TG13.1 – Roof Park Landscaping and Irrigation

Questions are numbered in the order received. Numbers missing in the sequence either have been answered in a previous response set or will be answered in a future set.

1 PRECAST CONCRETE ROOF DRAIN ENCLOSURE AT PLANTING AREA
LI-7665 SCALE: 3" = 1'

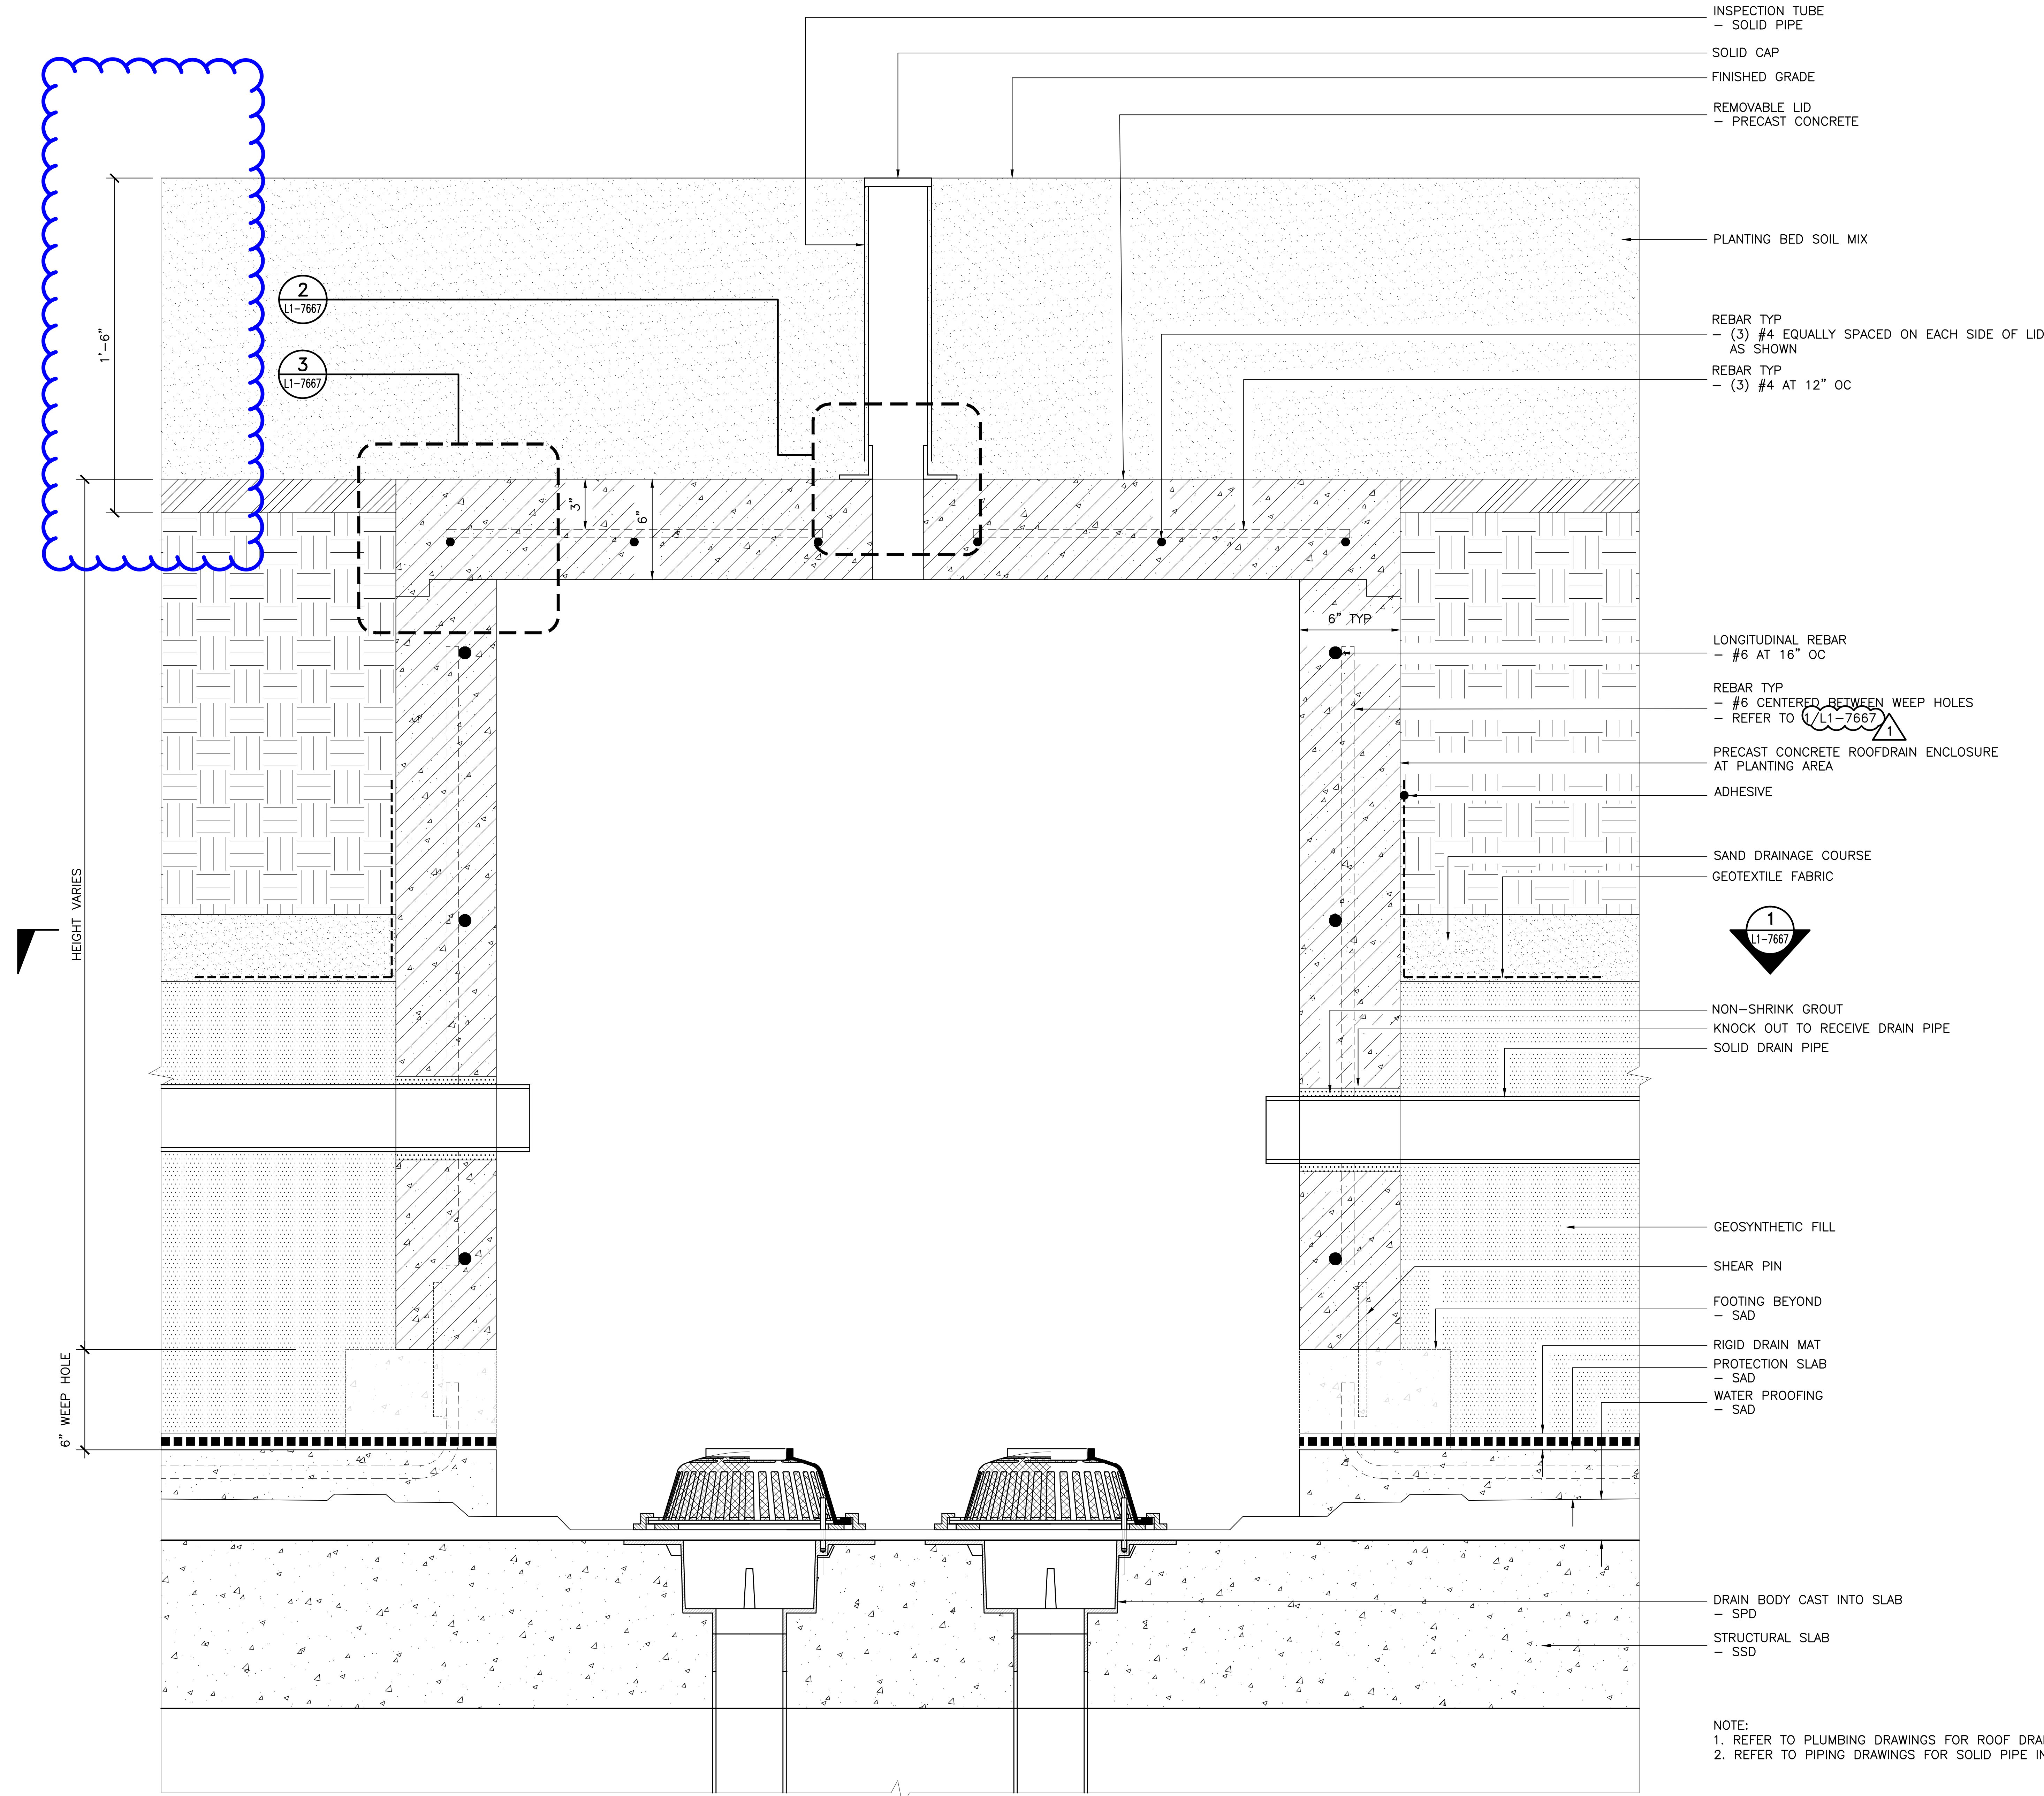
TG13.1-067	4/22/2015	03 45 00, Part 2 - Products; 2.3.B., L1-7664, L1-3602 through L1-3607, L1-4602 through L1-4607		We are requesting the Top of Lid Elevations for all the Precast Concrete Roof Drain Enclosures at Planting Areas that are shown on Sheets L1-4602 through L1-4607, in order to determine the overall heights required. Currently the only Top of Lid Elevations provided are those shown in Detail 1-Bamboo Grove Subslab Enlargement Plan on Sheet L1-2646.	The top of lid elevation of the precast concrete roof drain is 1'-6" below finish grade. Please refer to attached SKLA 401.0 for clarification.
TG13.1-068	4/22/2015	2/L1-9665, L1-5622 through L1-5627		We are requesting clarification as to the limits of where the ¾" Plywood and ½" Protection Board is to be installed around the 3" Waterproofing Assembly at the Beams. Are they to be installed only at the Beams within the Soil Mix Areas as shown on the Park Level Soils Plans Sheets L1-5622 through L1-5627?	Yes. The ¾" plywood and 1/2" protection board shall be installed only at the beams within the soil mix area, as shown on the park level soils plan. Refer to L1-5622 to L1-5627.
